Access Compliance Report Public Rights-of-Way (Pedestrian Signals)

Main Street: CRAWFORD_CANYON_RD Cross Street: BARRETT_LN Location: S

ADA ID: SGRK211007175546 Signal Type: One Push Button-APS Overall Compliance: No Severity Scores: BTN 1: 25 BTN 2: N/A No BTN: N/A

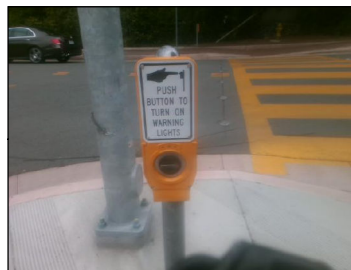
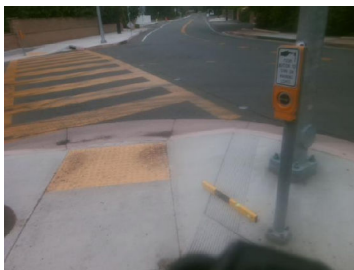
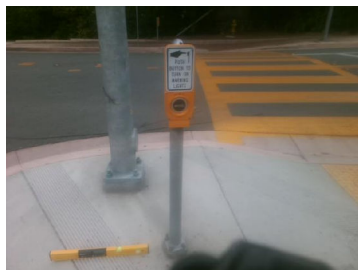
OC Std/PROW: R404.2

Possible Solutions: Remove and Replace Clear Space.
